ADDENDUM

Project:	COR Peach Road Center Renovation			Addendum # 02
Owner:	City of Raleigh			
Owner ID No.:	274-PR-PEACH 2023			
DKA Project No.:	2319			
Prepared By:	Jennifer Turner	Bid Documents Issue Date:	10.31.2023

Revision No. 001 City of Raleigh Comment Responses (Entire bid set issued to the City of Raleigh)

REVIEW COMMENTS & RESPONSES

A401

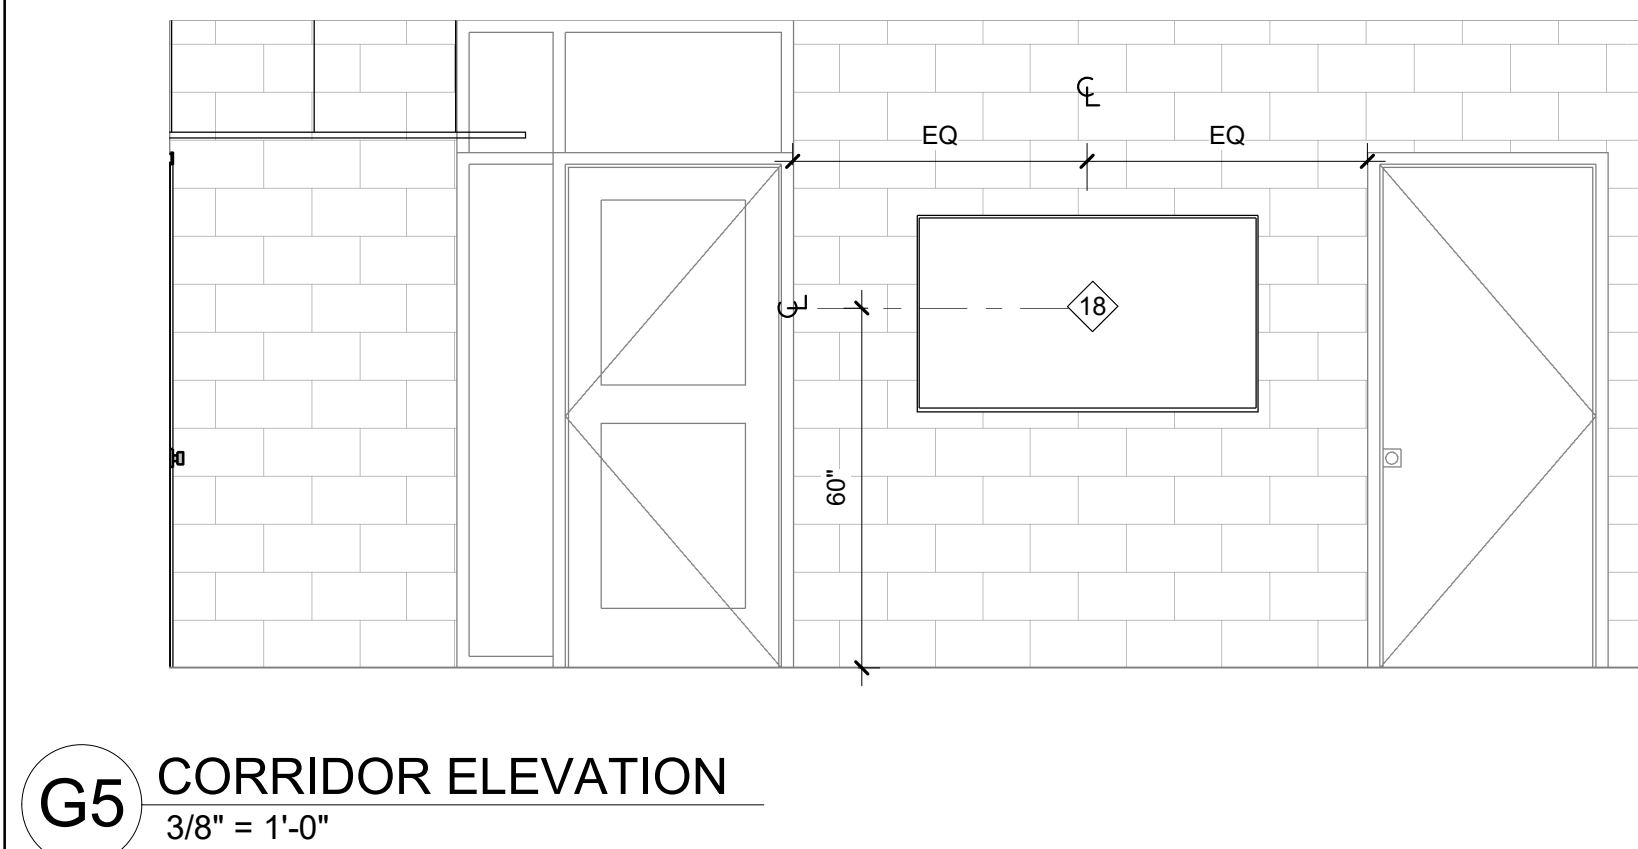
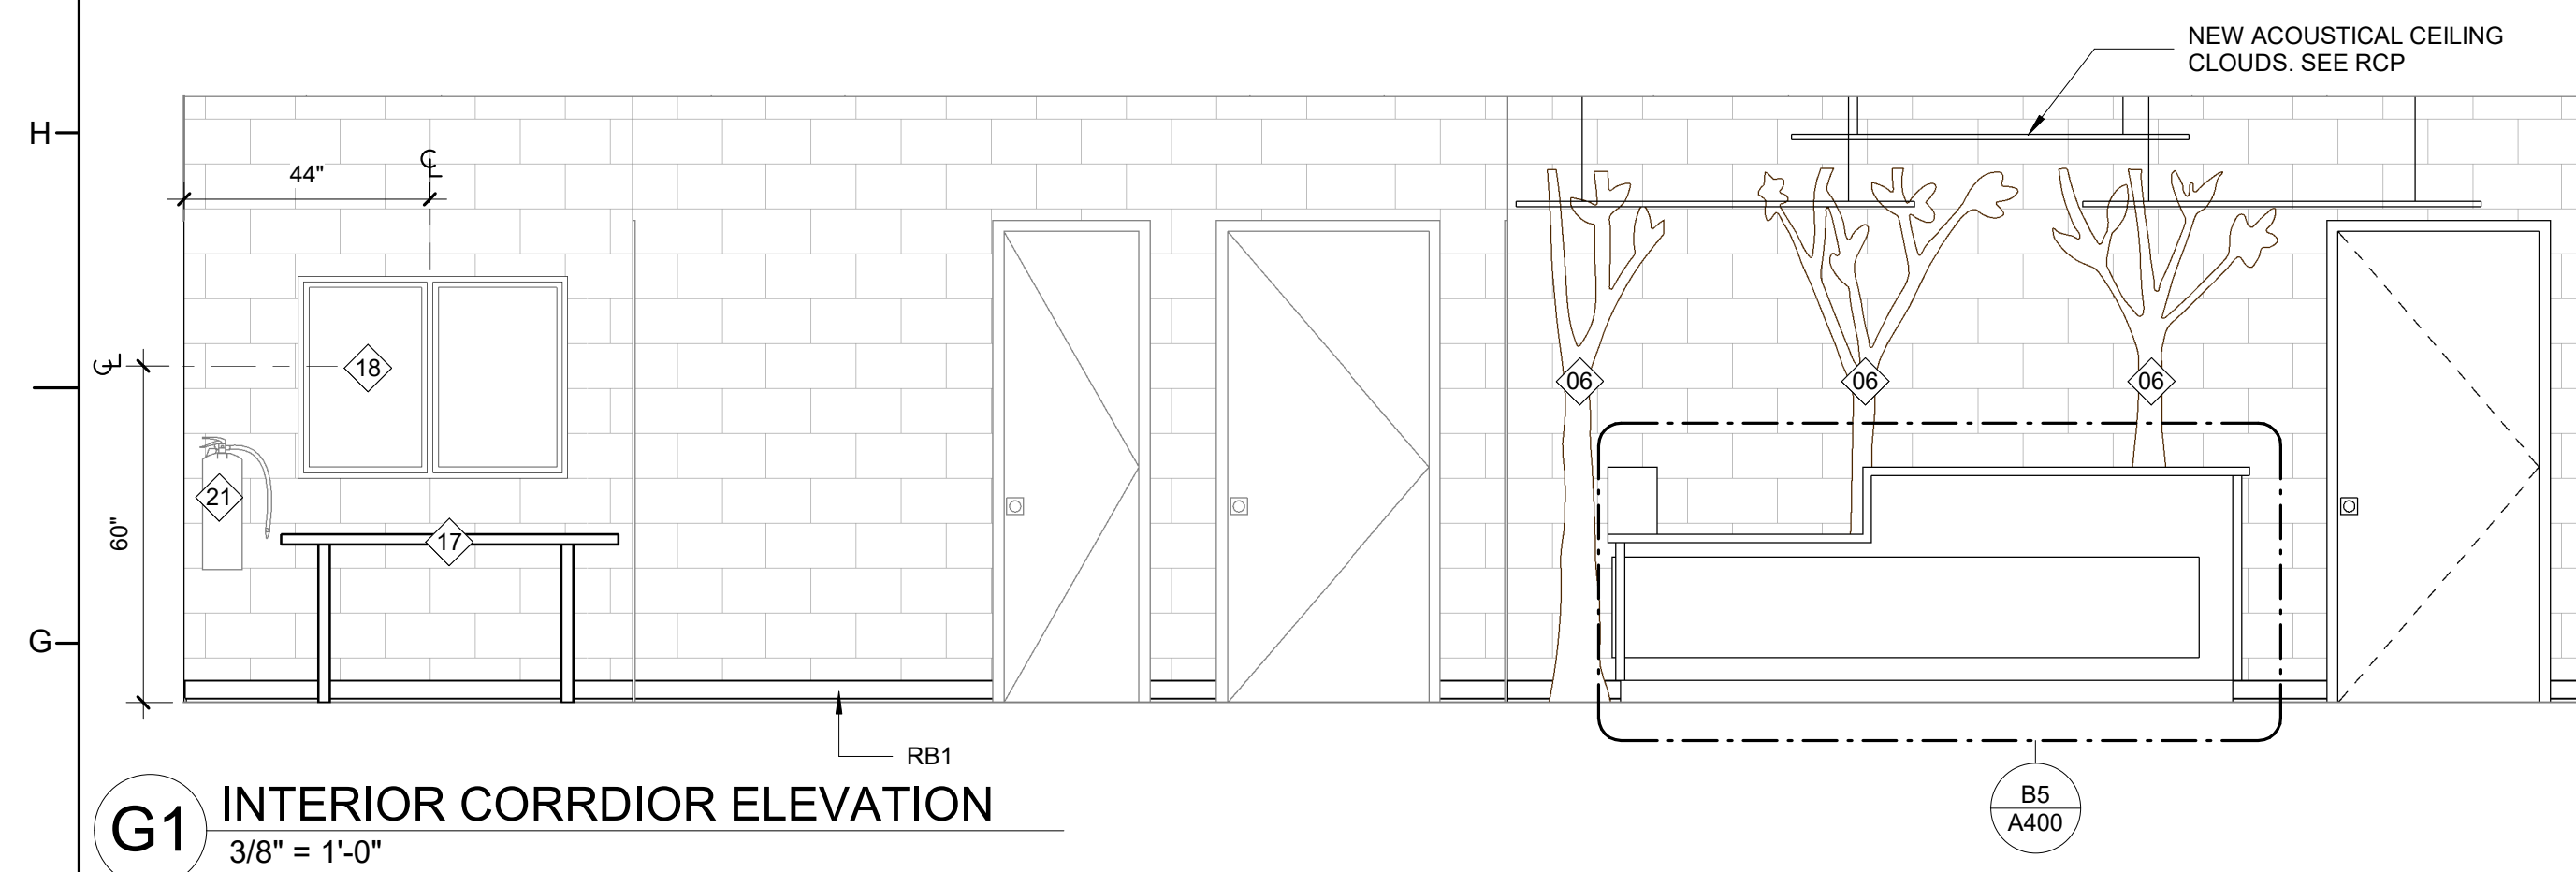
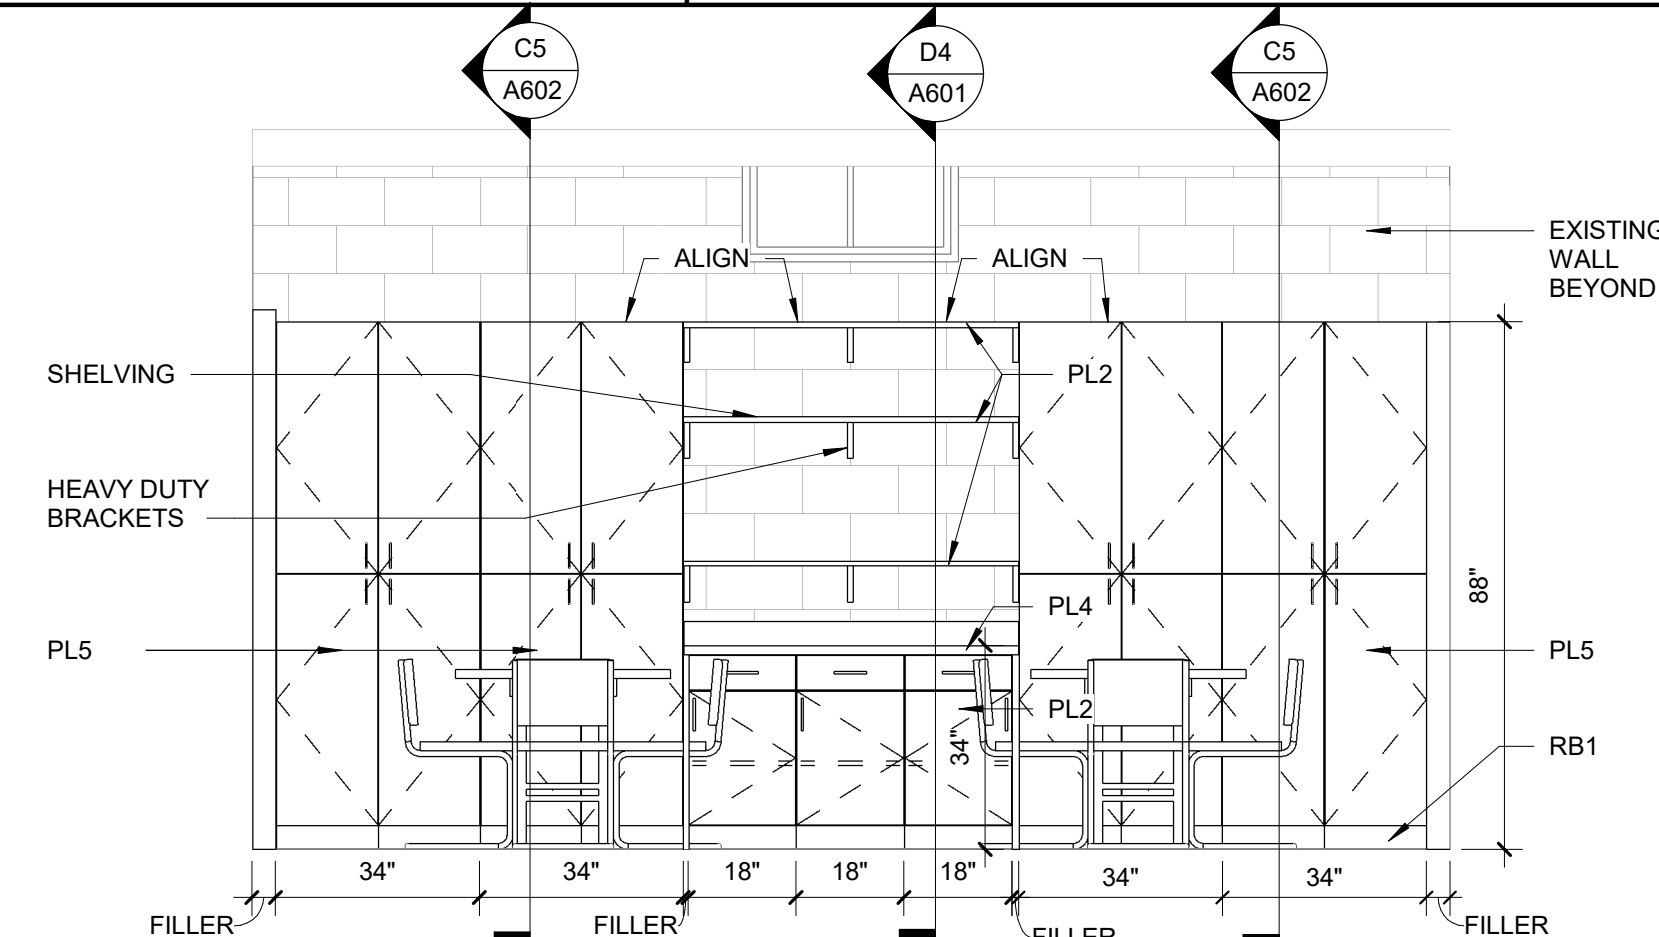
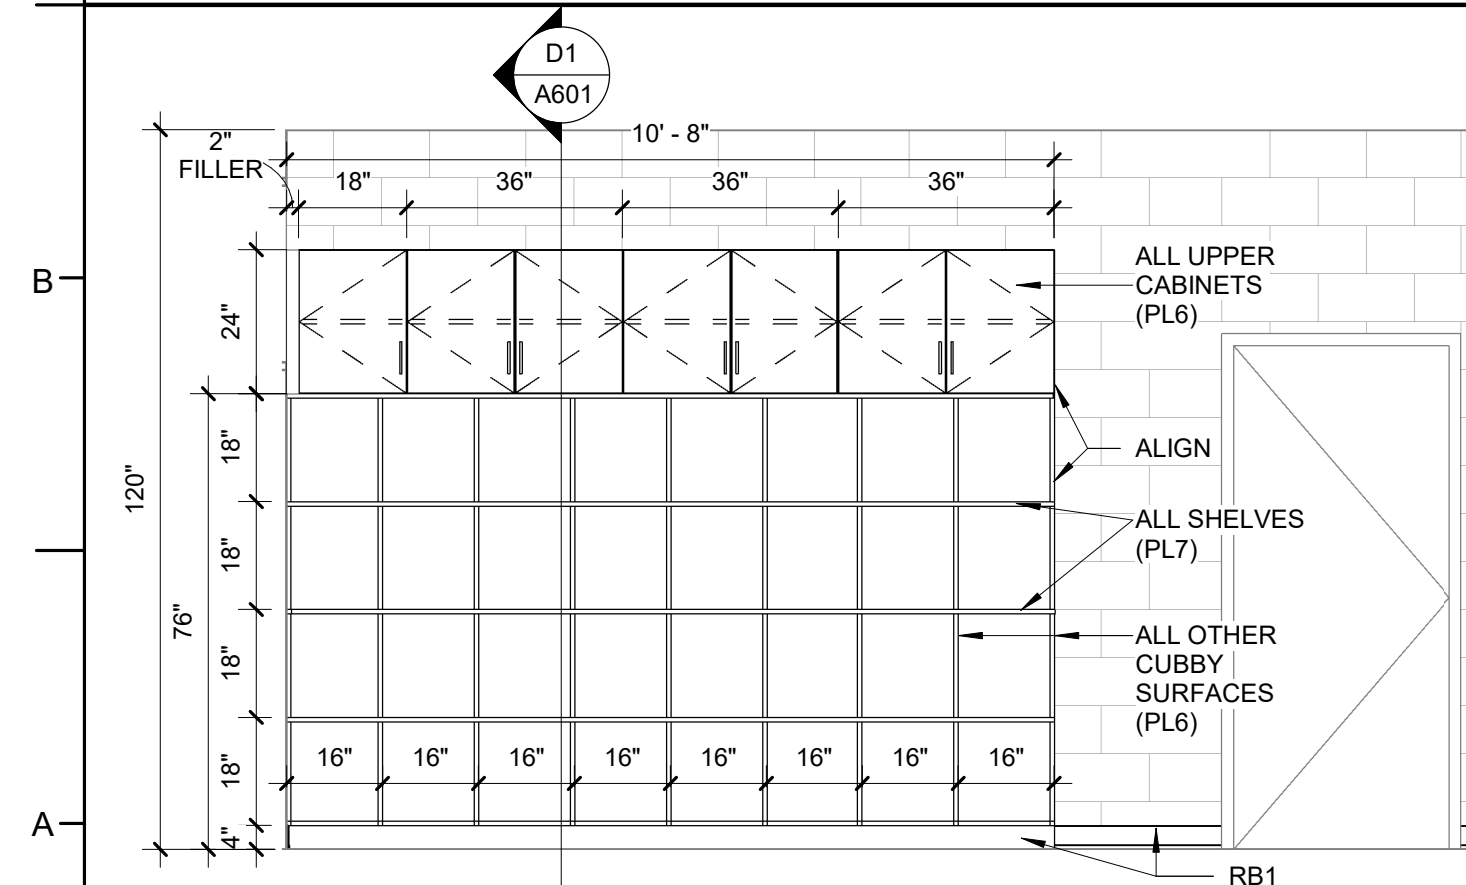
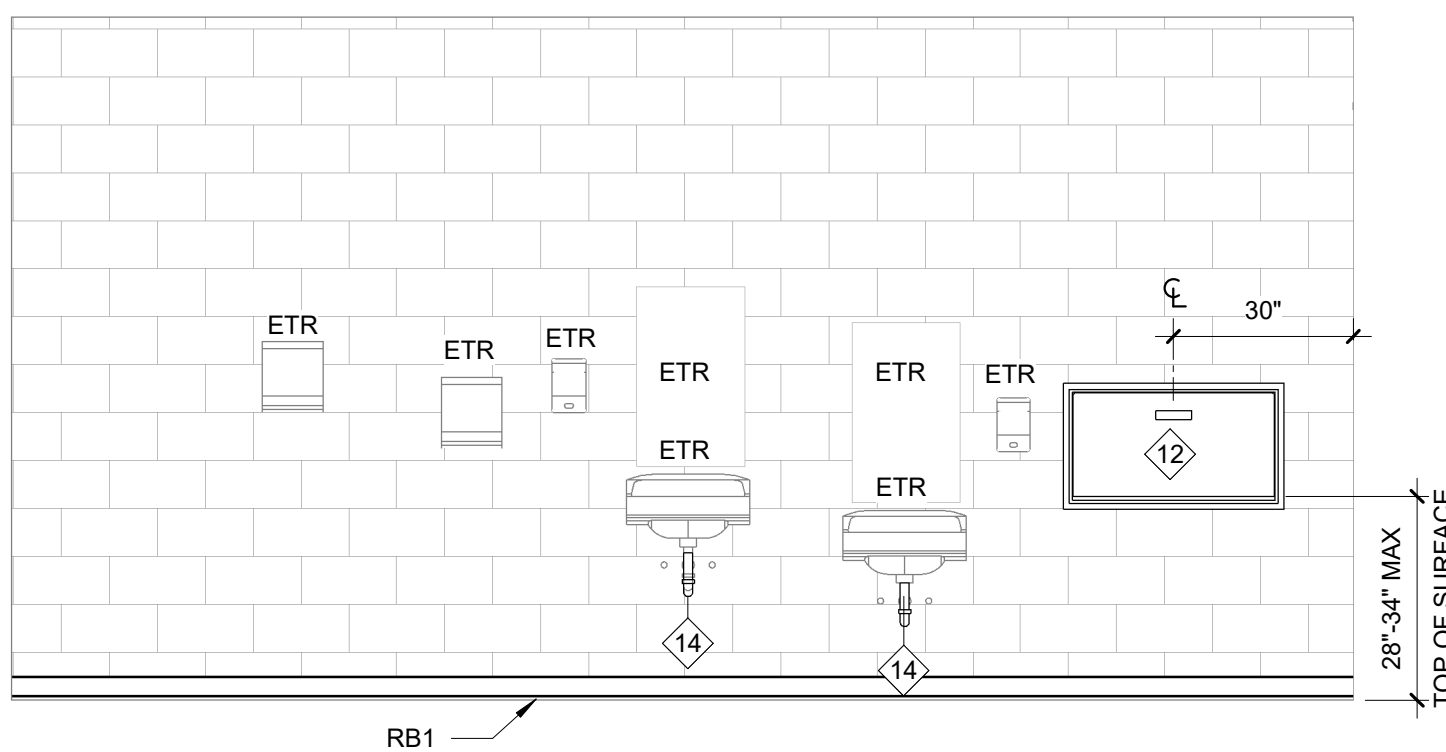
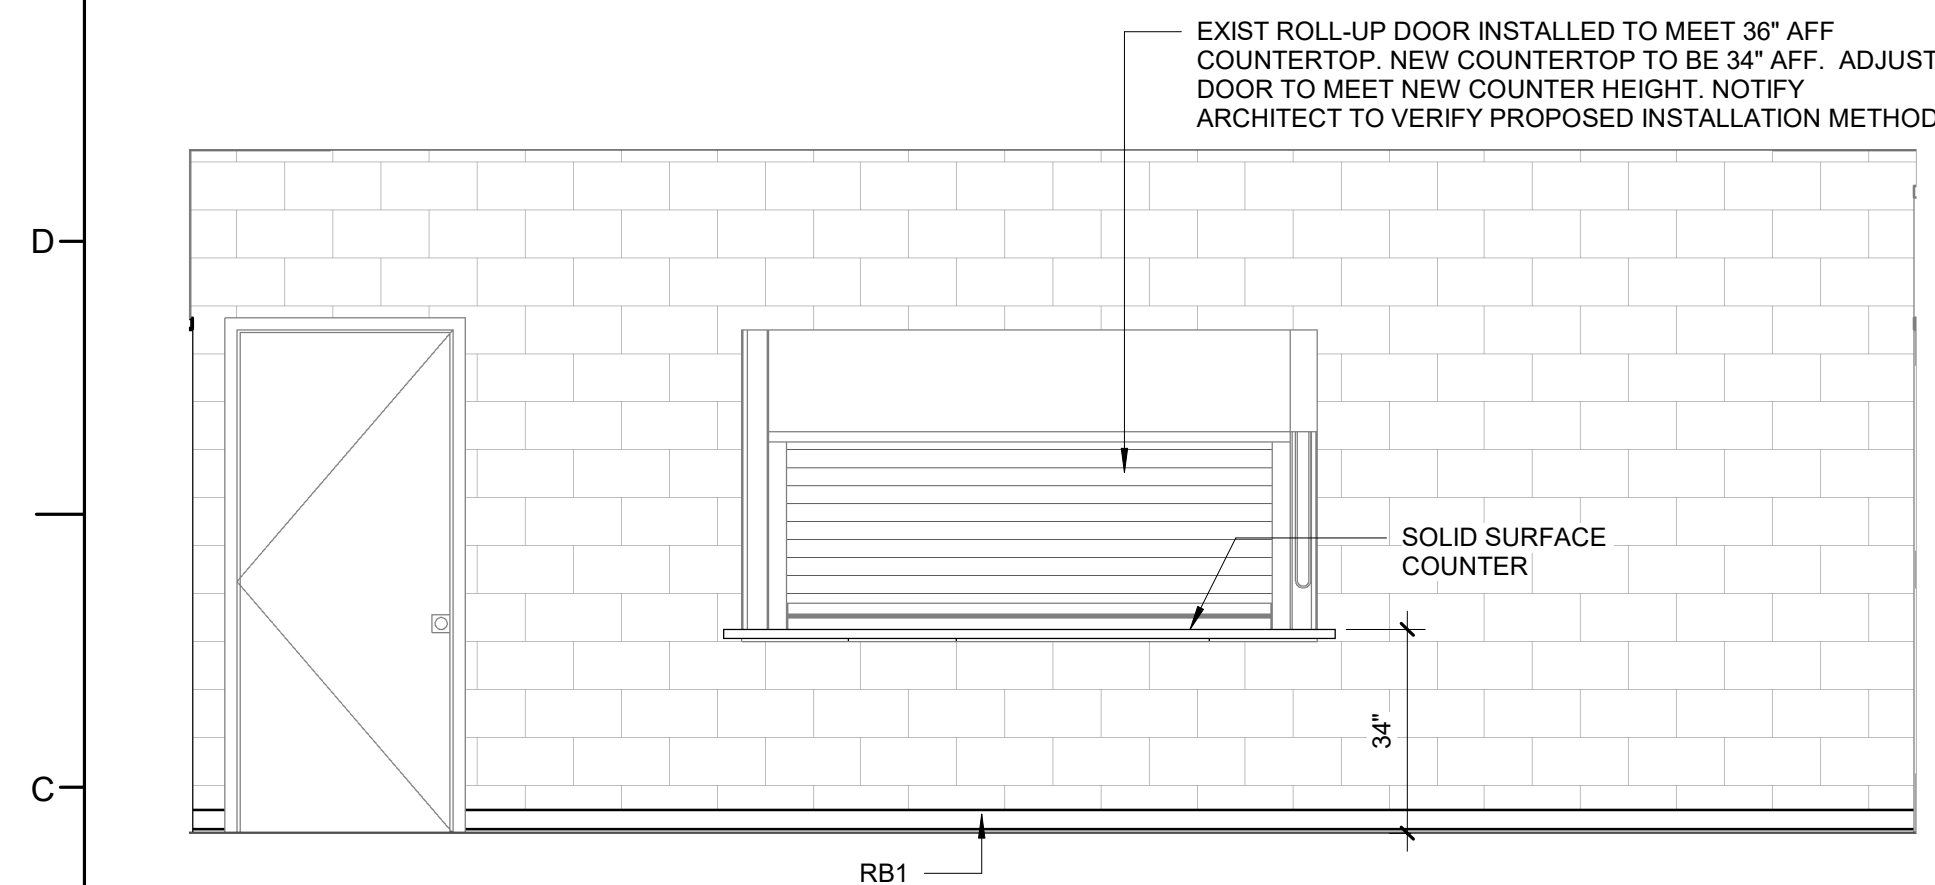
2. Reference E6/A401 – Is the new glass ¼” clear tempered?
 - a. Correct, clear tempered.
3. Reference A700 – Glass G2 High Impact Safety Glass...Do they mean ¼” laminated glass?
